**Addendum No. 1**  
**February 17, 2025**

Project: Lincoln High School Auditorium Renovation  
Sioux Falls, South Dakota  
Project #3021

Architect: Architecture Incorporated

### THEATRICAL CONTROL DEVICE SCHEDULE

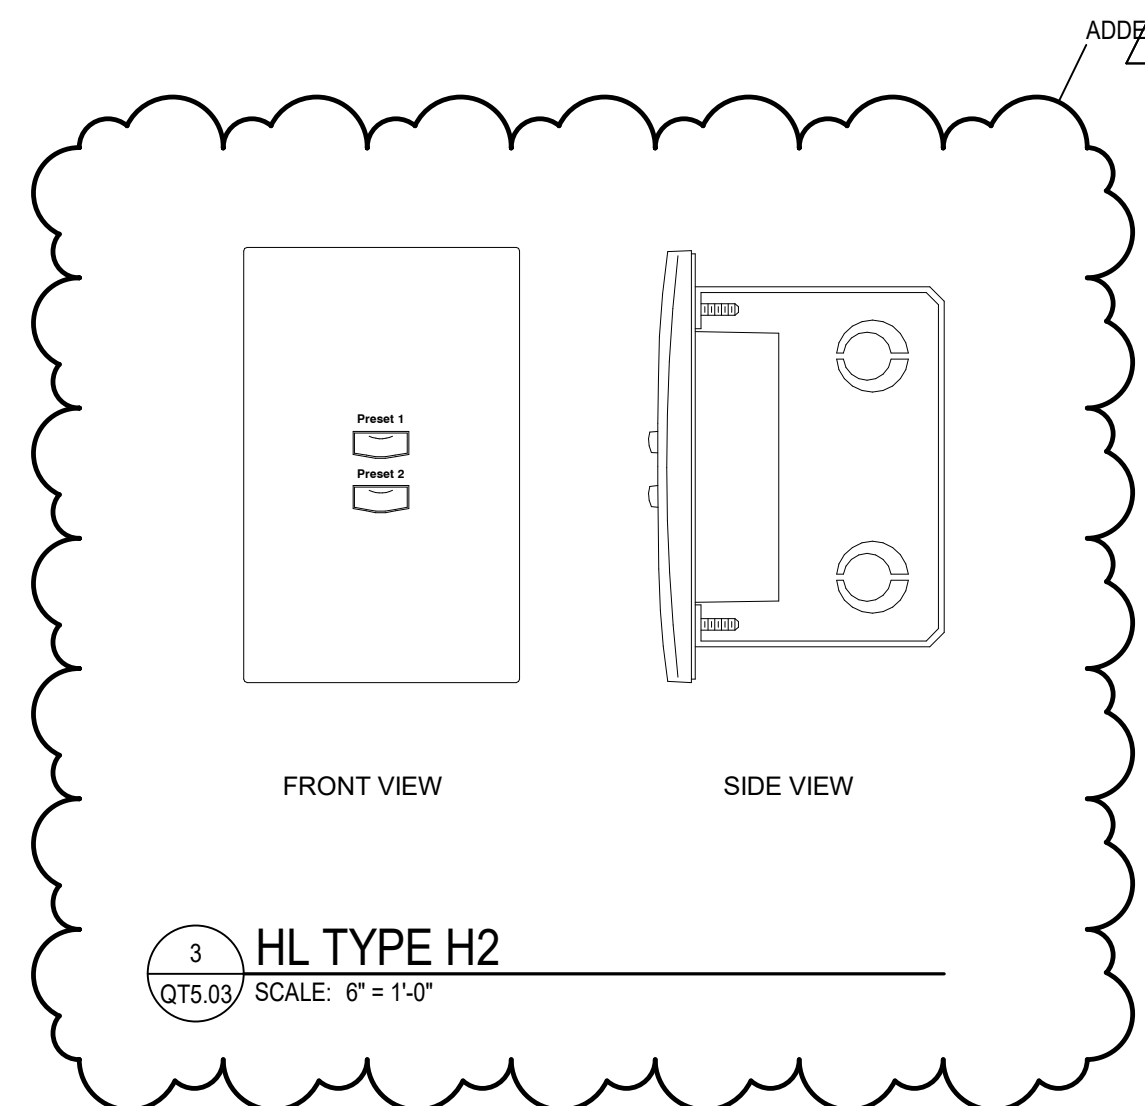
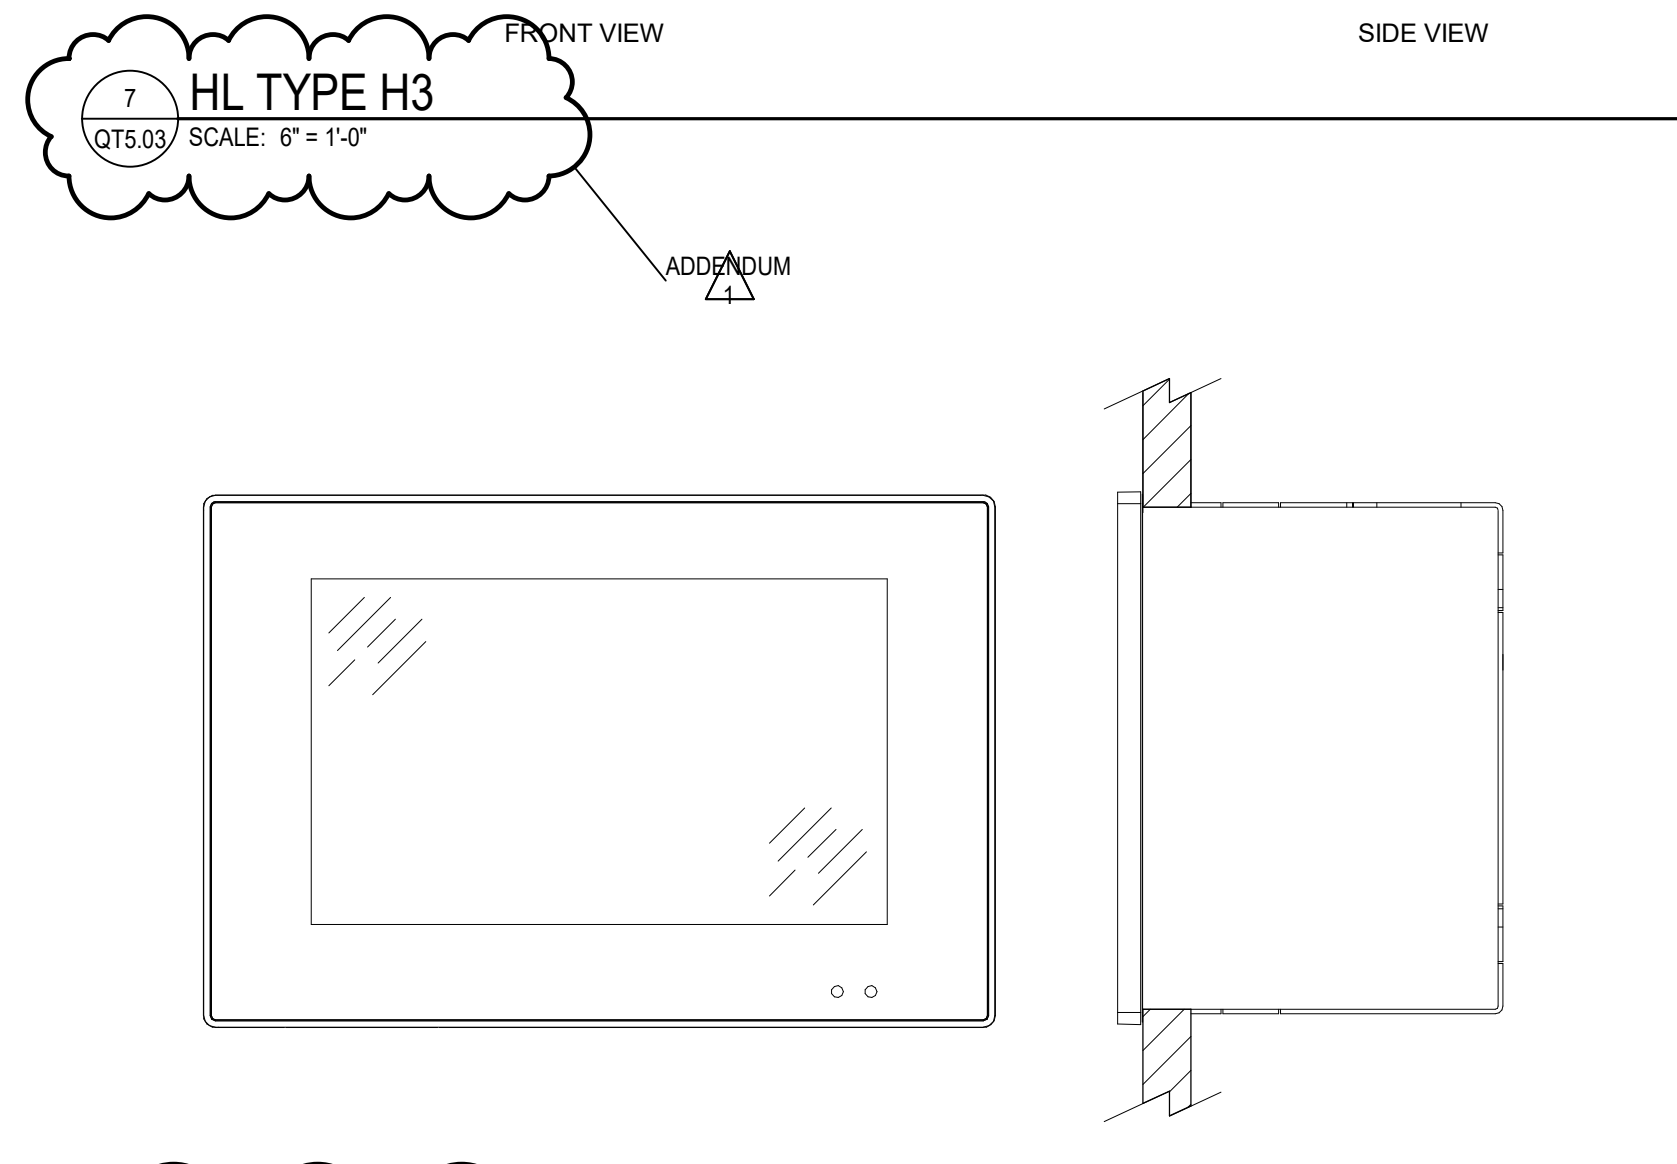
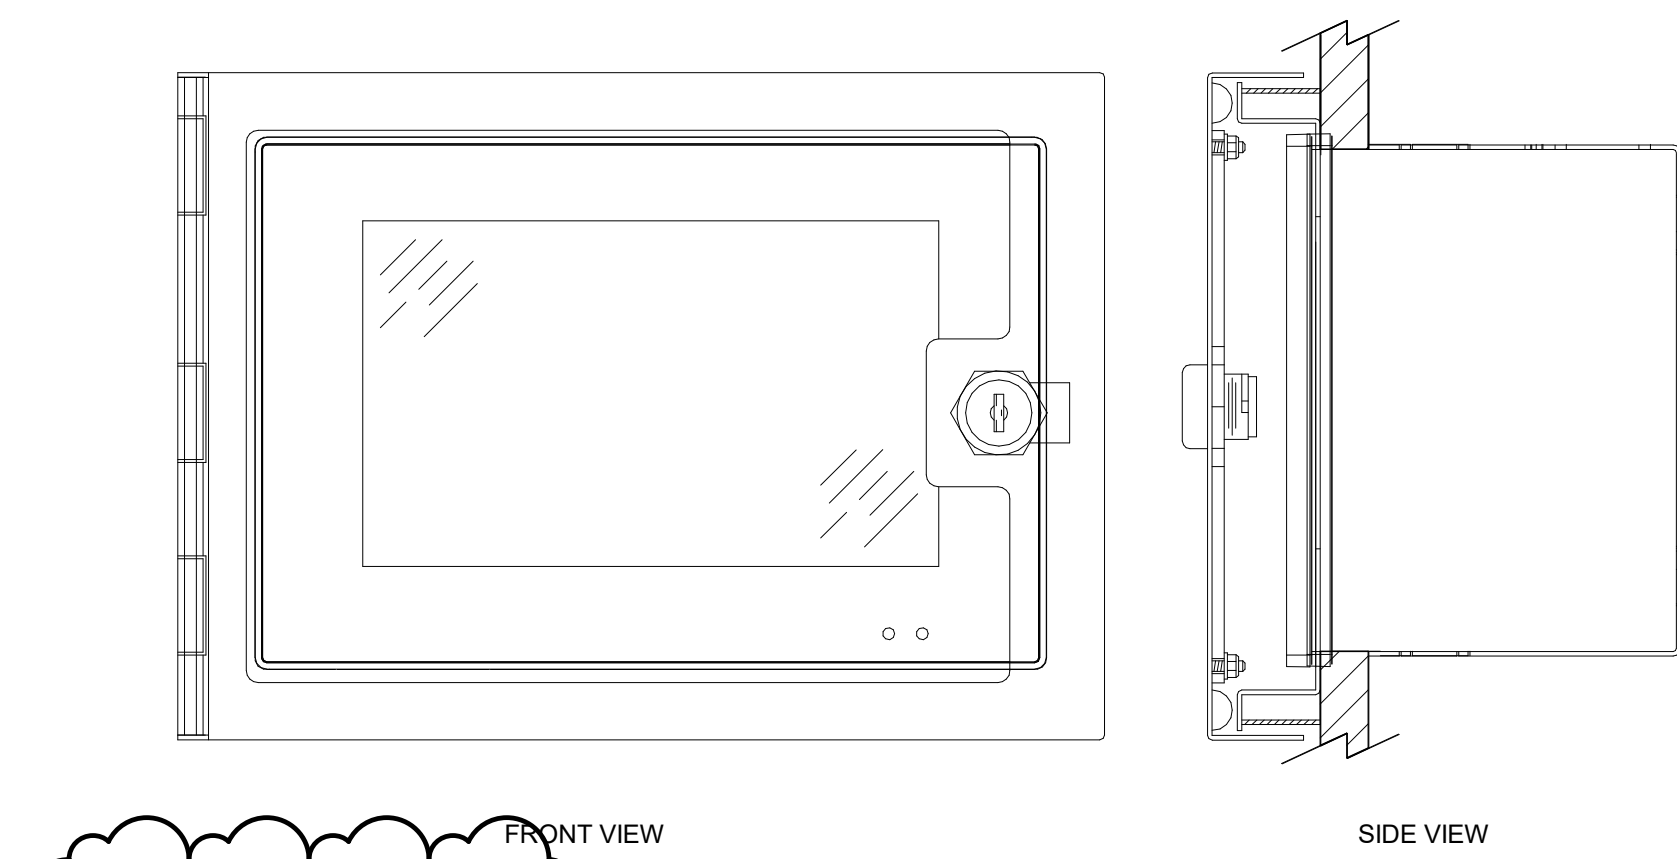
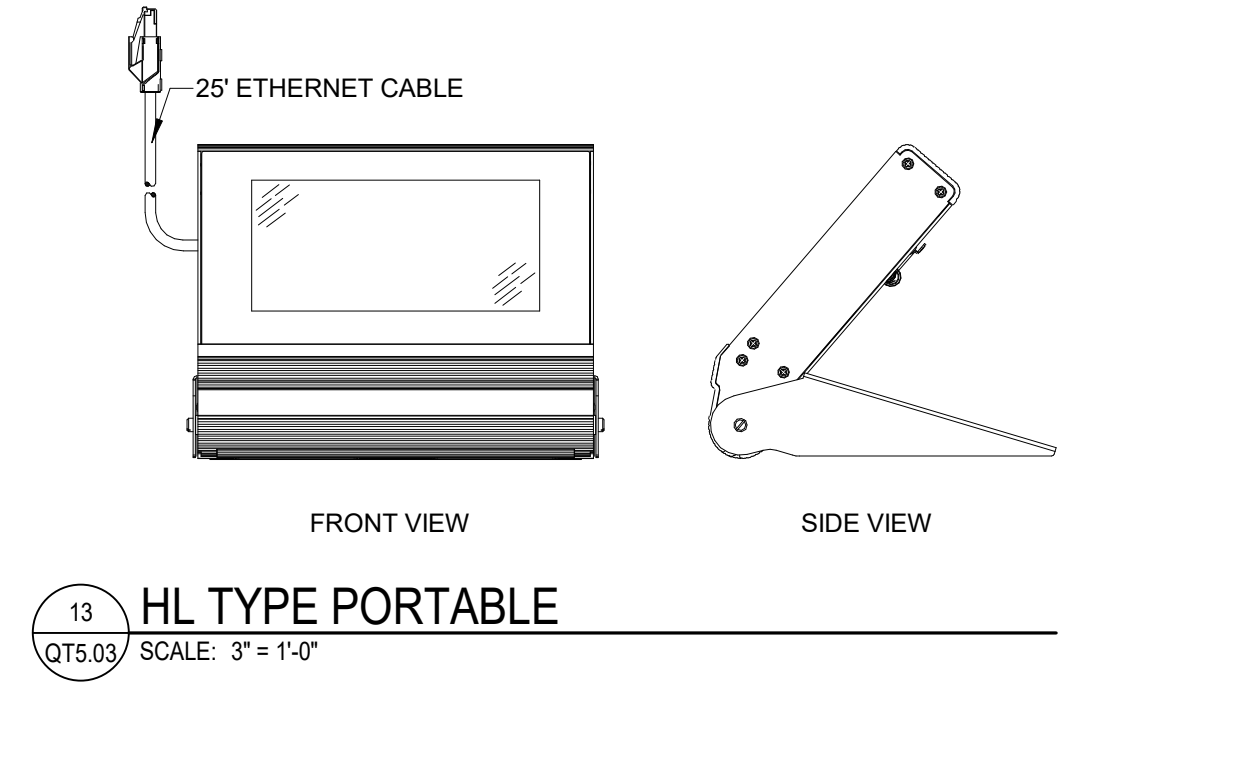
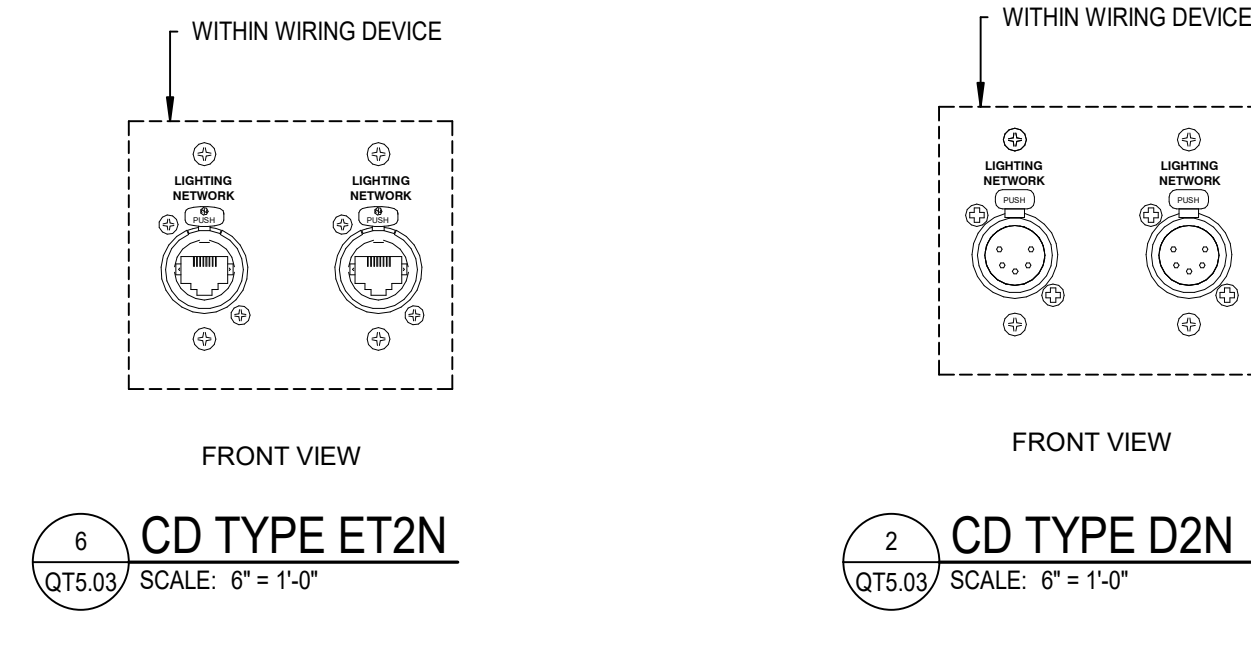
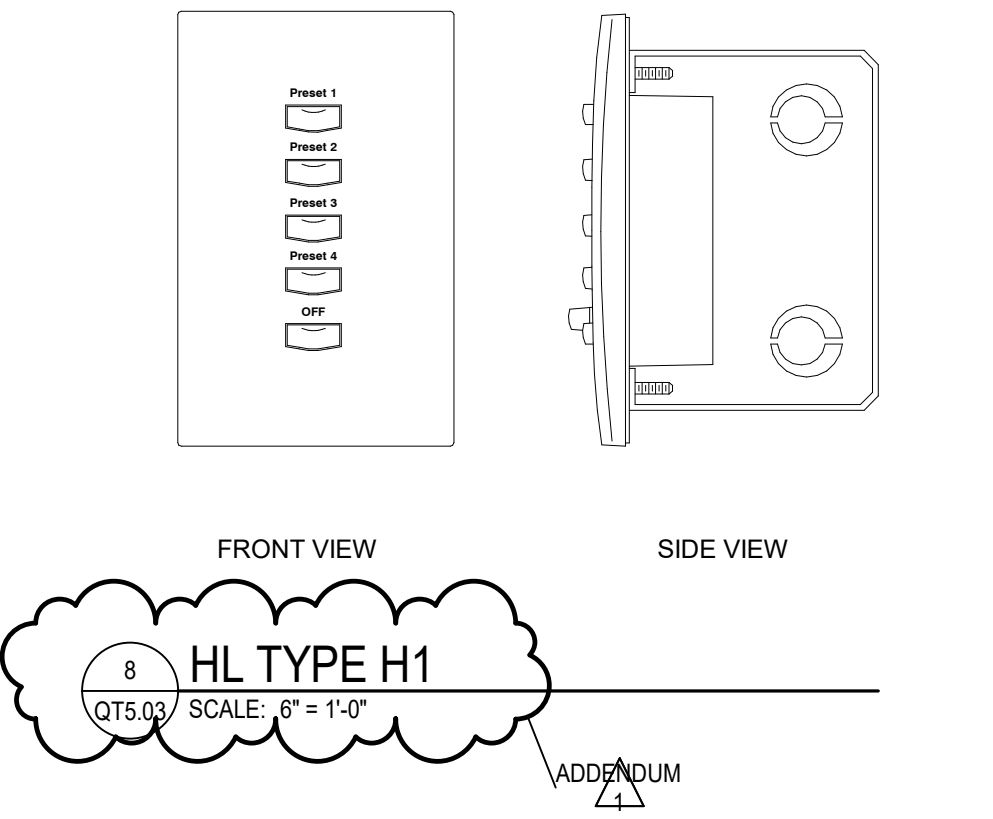
6) SHEET QT5.03– THEATRICAL CONTROL DEVICE DETAILS & SCHEDULE

- g. Revise detail names for details 1, 7, 8, and 11.
- h. Add detail 3 – HL TYPE H2
- i. THEATRICAL CONTROL DEVICE SCHEDULE
  - 1. Delete device ET-10
  - 2. Revise devices ET-09, ET-11, ET-12, and ET-13 to be wall mounted devices. See plan for details.
- j. THEATRICAL HOUSE LIGHT CONTROL STATION SCHEDULE
  - 1. Revise schedule per attached sheet.
